ADDENDUM NO. 2

San Antonio Water System

Project Name: **Olmos Basin Central Watershed Sewer Relief Line (C-3), Reaches 1 to 4**

Project No.: **08-2512**

GENERAL NOTES-2

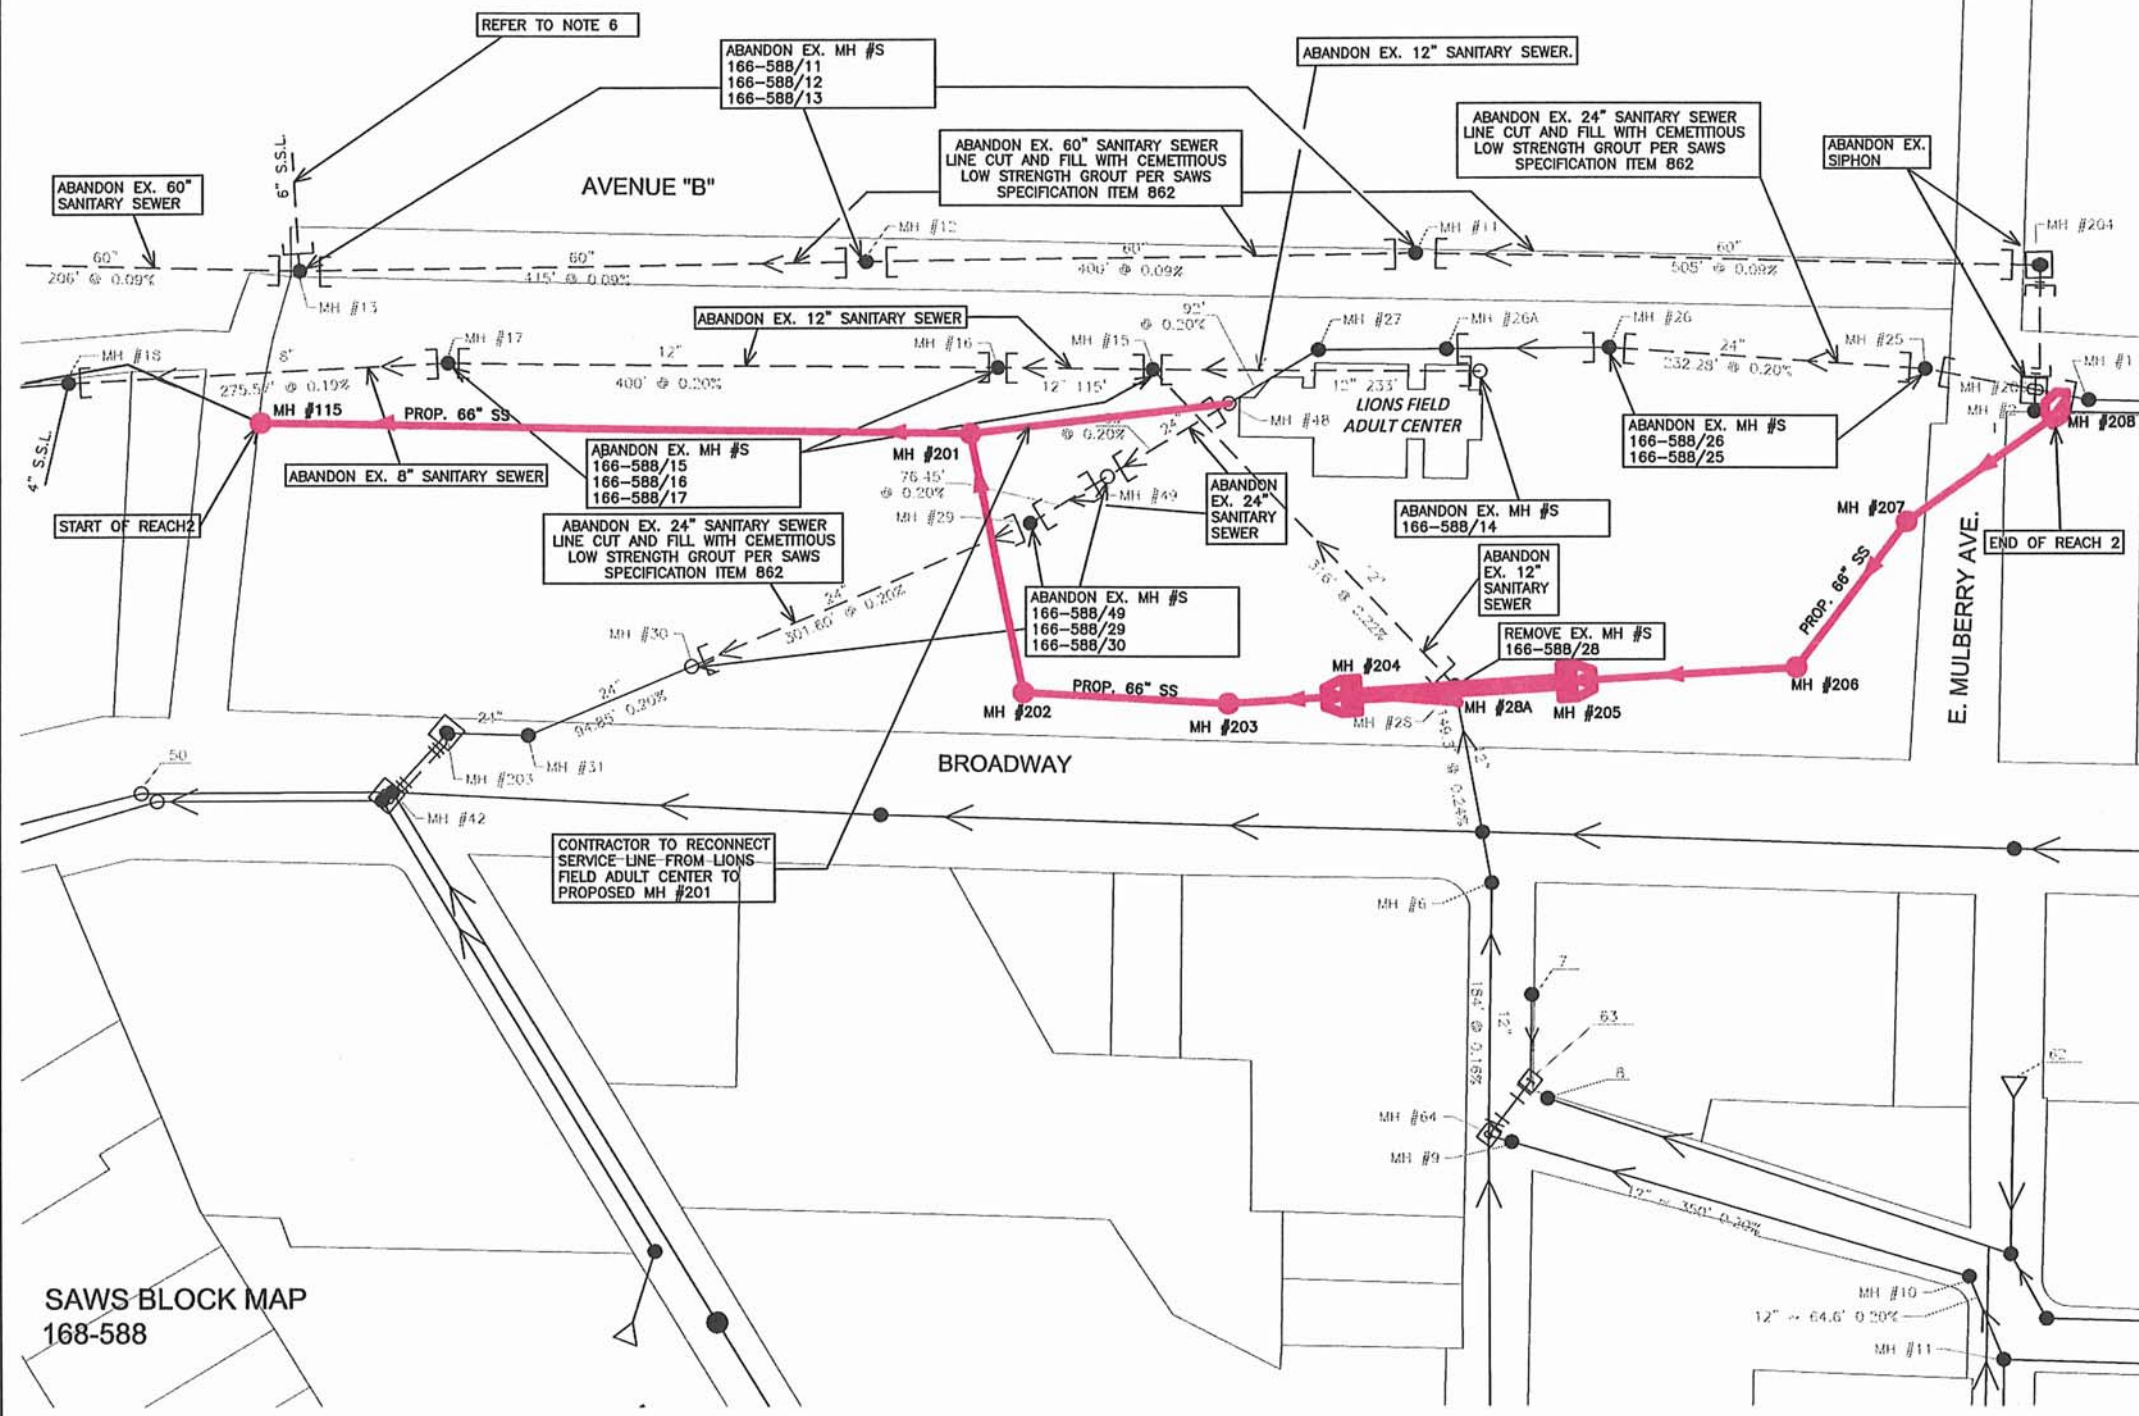
Item 1: Sheet G-002 – Remove and replace Sheet G-002 with the revised Sheet G-002 attached to this addendum. Revisions include:

- a) Under section entitled “Subsurface and Soil Conditions”, delete second sentence which reads “The report of their findings may be examined at the offices of the engineer.” In its entirety.

- b) Under section entitled “Excavation”, delete last paragraph (second paragraph under item 7) and replace with the following: “THE CONTRACTOR MUST STOP THE EXCAVATION IMMEDIATELY AND CONTACT THE SAWS INSPECTOR. THE CONTRACTOR CANNOT BEGIN EXCAVATION ACTIVITIES WITHOUT WRITTEN PERMISSION FROM SAWS.”

- c) Under section entitled “Excavation”, add the following paragraph: “8. ASBESTOS CEMENT (AC) PIPE, ALSO KNOWN AS TRANSITE PIPE AND WHICH IS KNOWN TO CONTAIN ASBESTOS-CONTAINING MATERIAL (ACM), IS LOCATED WITHIN THE PROJECT LIMITS. SPECIAL WASTE MANAGEMENT PROCEDURES AND HEALTH AND SAFETY REQUIREMENTS WILL BE APPLICABLE WHEN REMOVAL AND/OR DISTURBANCE OF THIS PIPE OCCUR. PAYMENT FOR SUCH WORK IS TO BE MADE UNDER SPECIAL SPECIFICATION ITEM NO 3000, “SPECIAL SPECIFICATION FOR HANDLING ASBESTOS CEMENT PIPE.””

- d) Add general note: “PROVIDE CONCRETE ENCASEMENT FOR ALL SEWER PIPES HAVING COVER LESS THAN 3 FT TO SUBGRADE. REFER TO DETAIL 3 ON SHEET D-1. NOTE CONCRETE ENCASEMENT MAY NOT BE SHOWN ON DRAWING PROFILES AT ALL LOCATIONS. CONTRACTOR SHALL PROVIDE CONCRETE ENCASEMENT PROTECTION OF PIPE BASED ON ACTUAL INSTALLED DEPTHS. ALL CONCRETE ENCASEMENT INSTALLED SHALL BE INDICATED ON REDLINES/RECORD DRAWINGS.’

SAWS OLMO BASIN CENTRAL WATERSHED
 SEWER RELIEF LINE (C-3) REACHES 1-4
 REHABILITATION AND ABANDONMENT
 PLAN FOR EXISTING SEWER SYSTEM REACH-2

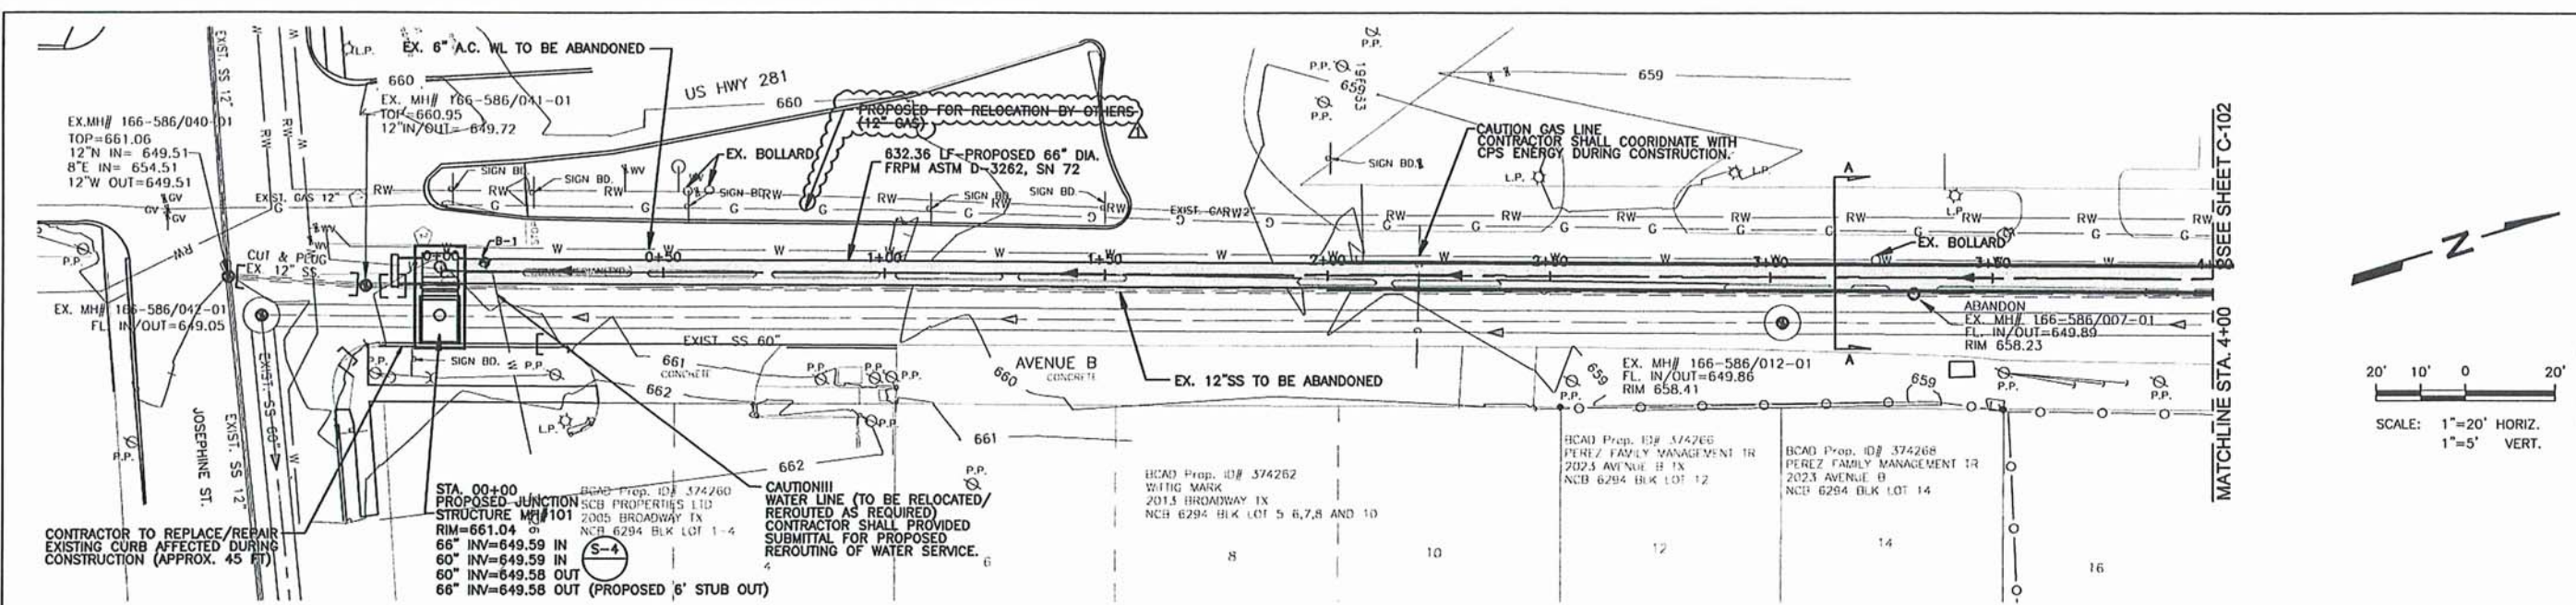
Item 3: Sheet R/A-201 – Remove and replace Sheet R/A-201 with the revised Sheet R/A-201 attached to this addendum. Revisions include:

- a) At end of Note #6, delete “(APPROXIMATELY 900 FT.)” and replace with “(REFER TO SHEET C-110).”

SHEET NO. C-101 14 OF 123

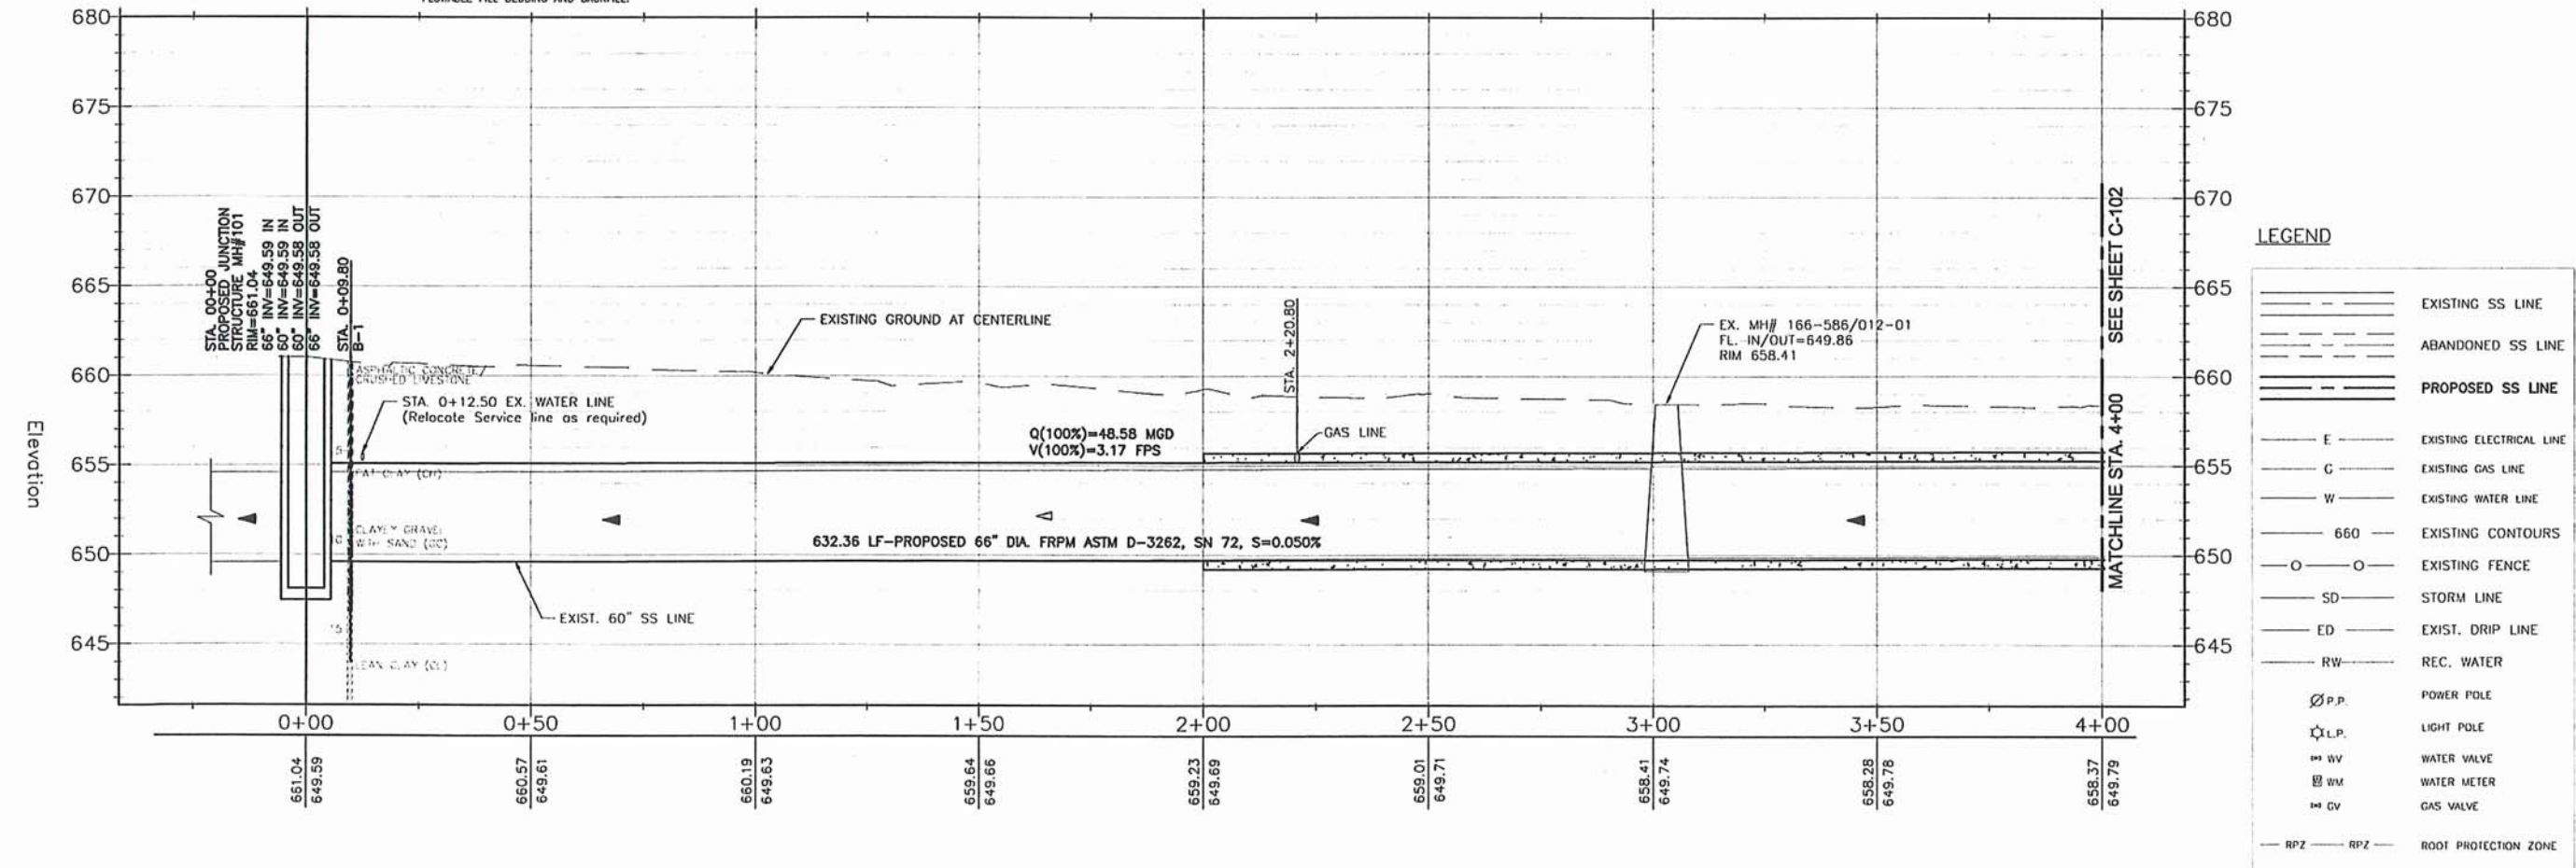
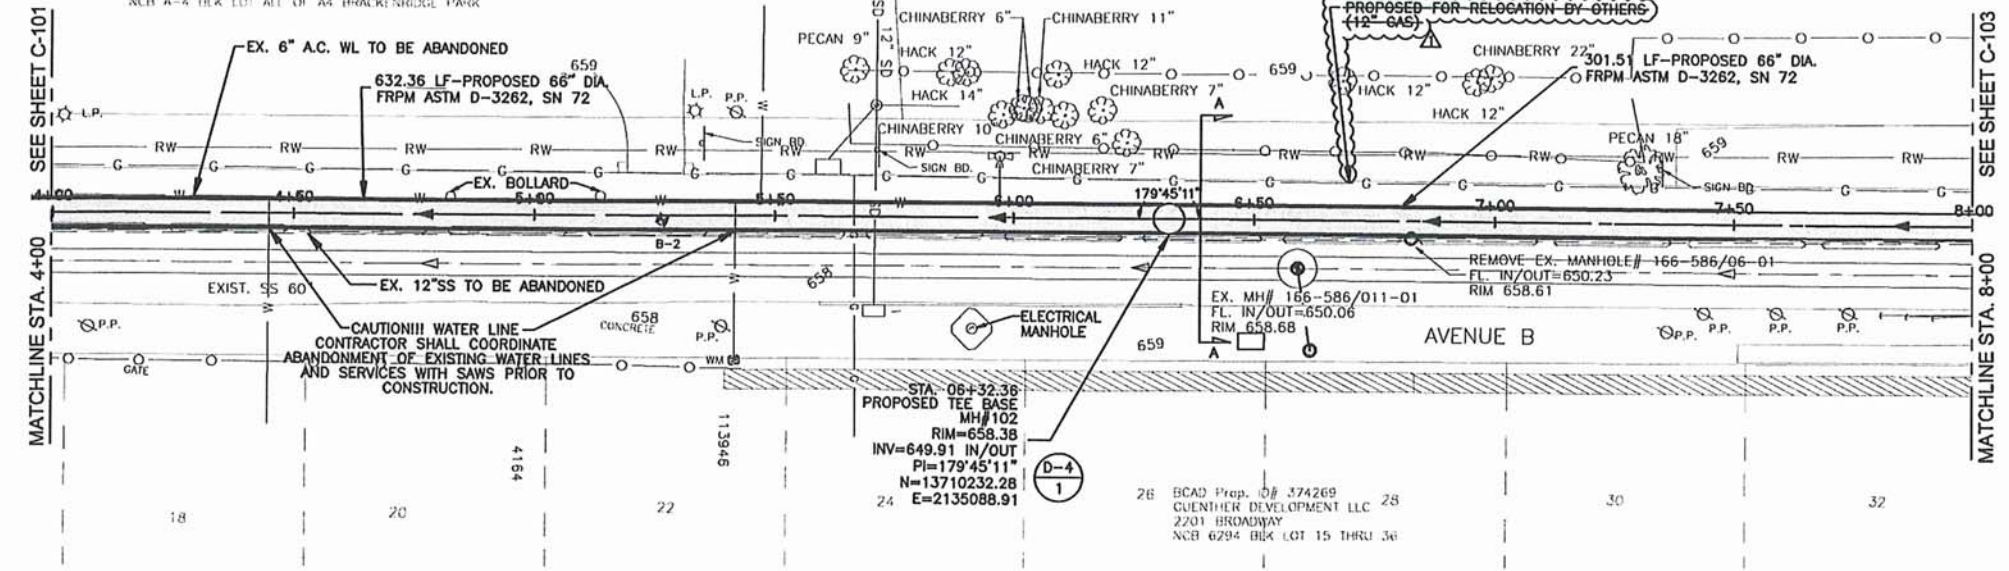
Item 4: Sheet C-101, C-102, and C-103 – Remove and replace Sheet C-101, C-102, and C-103 with the revised Sheet C-101, C-102, and C-103 attached to this addendum. Revisions include:

- a) Delete callout on existing 12” gas line that reads:
“PROPOSED FOR RELOCATION BY OTHERS (12” GAS)”.
Note that the existing 12” gas line on Reach 1, from approx. Sta. 9+00 to approx. 14+50, is planned for abandonment by CPS prior to this SAWS Olmos C-3 project.
